CITY OF CODY
PLANNING, ZONING AND ADJUSTMENT BOARD
TUESDAY, FEBRUARY 10, 2015
CITY HALL COUNCIL CHAMBERS @ 12:00 NOON

MEETING DATE:	FEBRUARY 10, 2015	TYPE OF ACTION NEEDED	
AGENDA ITEM:		P&Z BOARD APPROVAL:	
SUBJECT:	FINAL PLAT OF THE REBEL ROW MINOR SUBDIVISION SUB 2014-04	RECOMMENDATION TO COUNCIL:	X
PREPARED BY:	TODD STOWELL, CITY PLANNER	DISCUSSION ONLY:

FINAL PLAT

REBEL ROW MINOR SUBDIVISION
 LOCATED WITHIN LOT 11 OF ROCKY MOUNTAIN BUSINESS PARK SUBDIVISION, WITHIN TR 70 B OF THE TUTTLE SUBDIVISION,
 RESURVEY T.53N. R. 101 W., 6TH P.M.,
 CITY OF CODY, PARK COUNTY, WYOMING

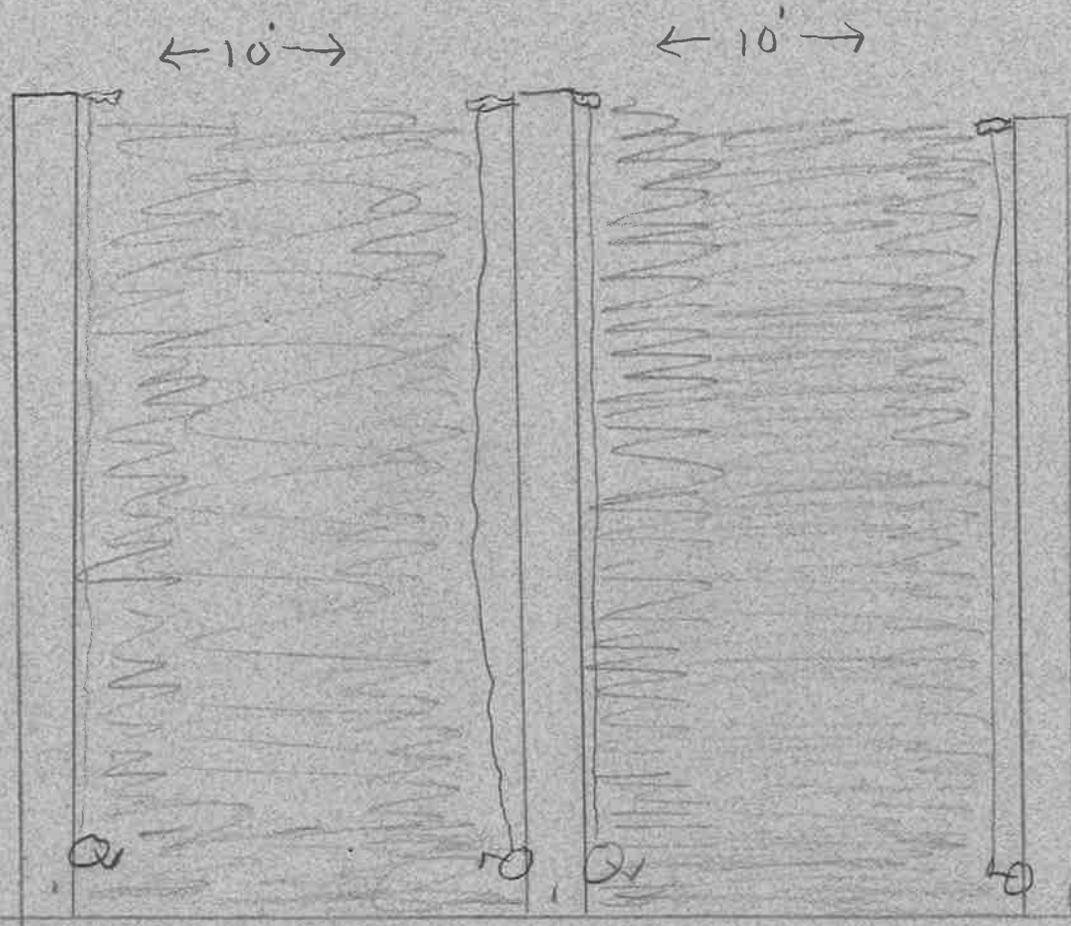
The intent of the review is likely to ensure that the request is context sensitive, in that the fence location, type, and height are appropriate to the surrounding uses. In this case, the fence is entirely internal to a city park, over 700 feet from the nearest residence, does not create any visual safety issues, and will be designed so that it does not blow over onto the adjacent roadway.

Approve or deny the request. If approved by the Board, a building permit from the Building Official and authorization from the Parks Department will also be required.

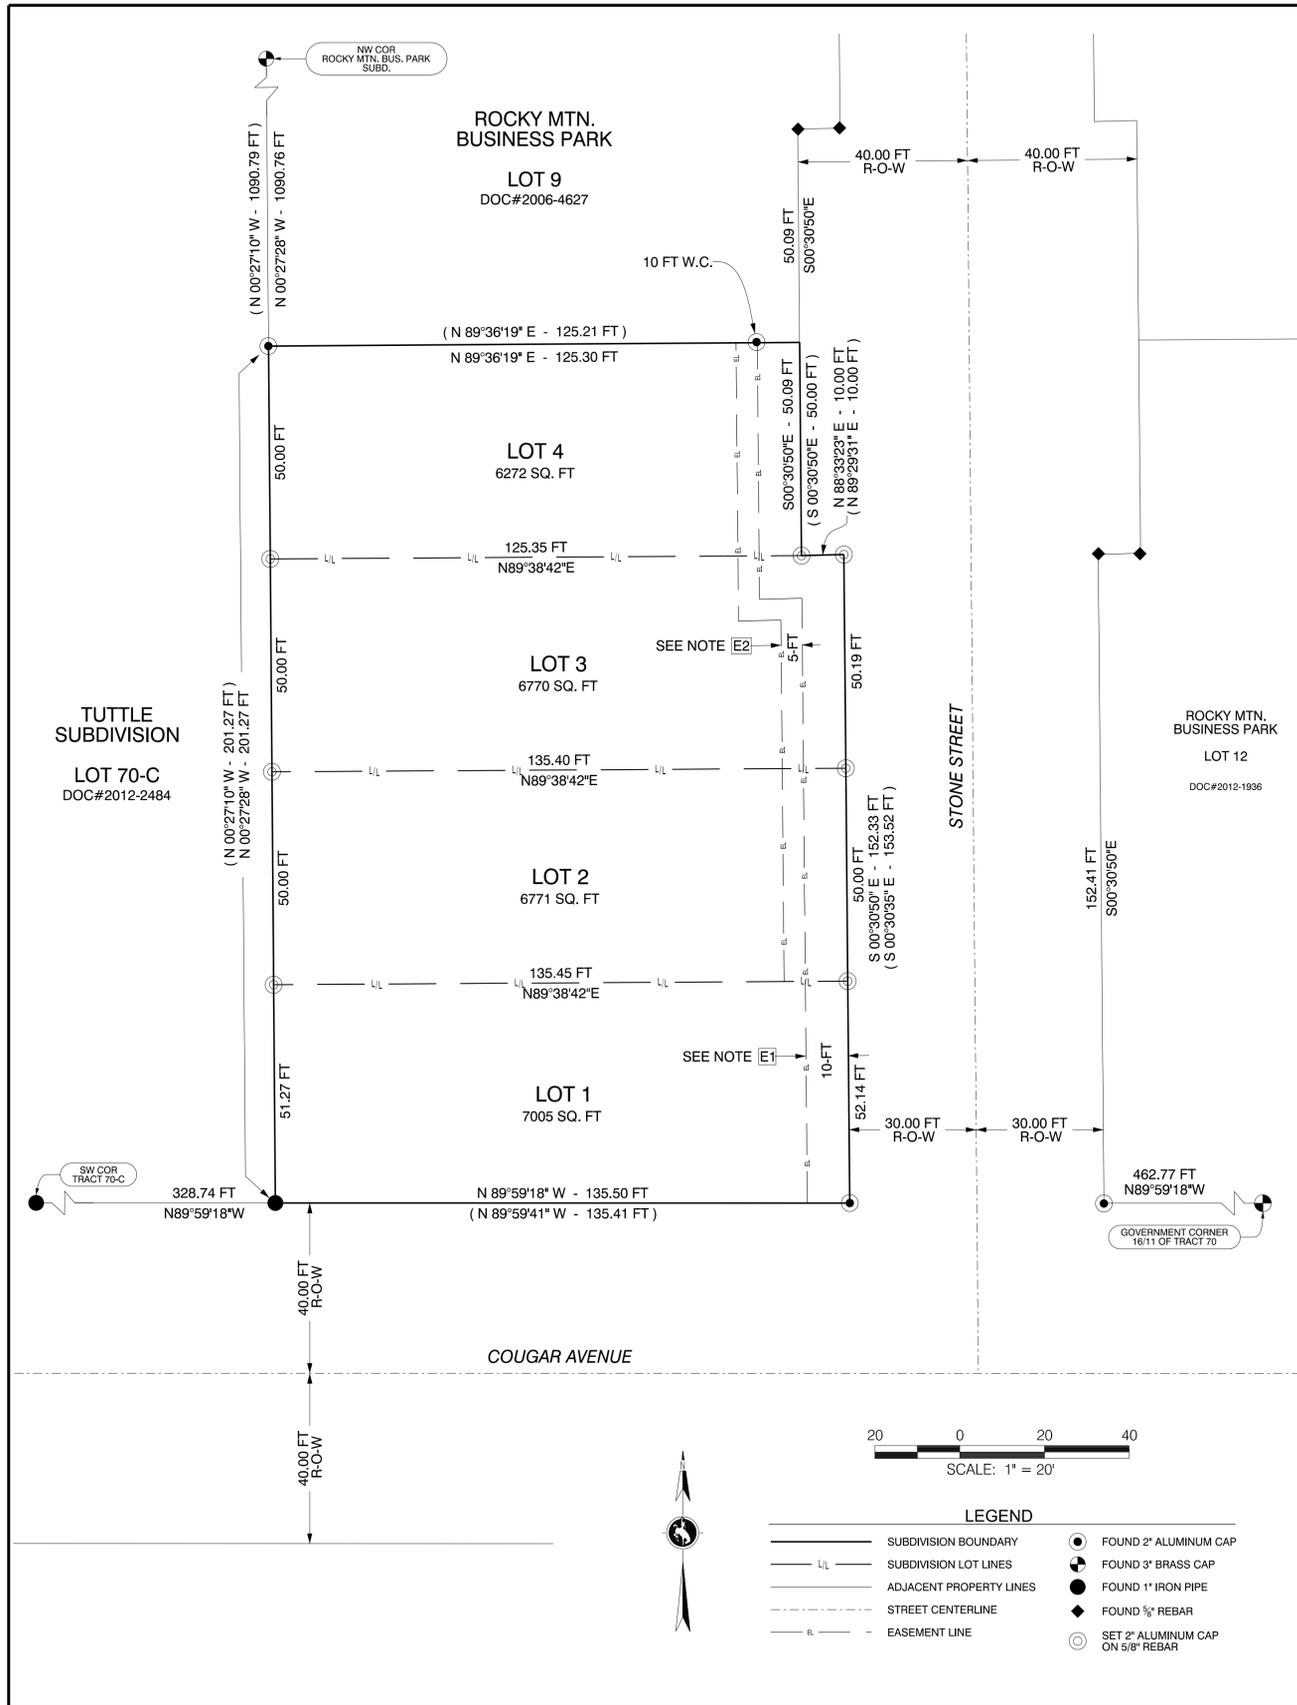
Comment: Met. The language is included.
2. The street cuts for the water and sewer services to Lots 1 and 2 must be repaired with a single patch. An encroachment permit for the work within the street right-of-way is required.

Comment: The requirement has been noted on the preliminary plat, which in this case acts as the plans for construction.
3. Add a note to the preliminary plat regarding the modifications to the storm water facilities in front of Lot 4 as described in the surveyor's letter dated December 23, 2014.

Comment: Met.
4. Provide an additional five feet of utility easement across Lots 2, 3 and 4. If the transformer is to be located on the property between Lot 4 and the lot to the north,

a separate easement document will be needed for the portion on that lot to the north (owned by the applicant).

Comment: Only partially met. The 5-foot easement across Lots 2, 3 and 4 is shown. However, a 5' by 5' easement is needed on the lot to the north for the new transformer. The easement document will need to be provided and recorded with the final plat.

5. Sidewalk shall be installed to City standards where it does not exist along the west side of Stone Street from Cougar Avenue to the sidewalk on the Sherwin Williams store lot. Prior to issuance of any building permits these sidewalk improvements shall be installed, or the developer must provide a cash deposit for construction cost plus 10% to be held by the City for security until the sidewalk is completed. The sidewalk improvements shall be completed within 24 months of approval of the subdivision.

The sidewalk must be continuous, meaning that part of the driveway to Lot 4 must be installed to connect the section of sidewalk behind the percolation trench with the sidewalk immediately behind the Stone Street curb. Furthermore, no parking can occur on this section of sidewalk that crosses the driveway. The no parking restriction is to be noted on the preliminary plat.

Comment: The requirements are noted on the preliminary and final plat.

6. Otherwise complete the improvements required by the subdivision ordinance and as noted on the preliminary plat. Utility connection fees will be collected with the final plat.

Comment: The physical construction items (utility services and storm water trench) will need to be completed before building permits can be issued. The water tap fees and electrical estimate will need to be paid prior to the mayor signing the final plat.

Recommend that the City Council approve the Final Plat for the Rebel Row subdivision, subject to the following:

1. Applicable utility fees (three water taps and the electrical estimate) shall be paid prior to the mayor signing the final plat.
2. Provide a minimum 5-foot by 5-foot utility easement on Lot 9 of the Rocky Mountain Business Park, for the new transformer. The easement must be recorded prior to, or with the final plat.
3. All utility work for sewer, water, power, and storm water must be completed as noted on the preliminary plat prior to issuance of a building permit. The work must conform to city standards.
4. Comply with Condition 5 of the preliminary plat approval, relating to constructing or providing a cash deposit for construction of sidewalk along the west side of Stone Street prior to issuance of a building permit.
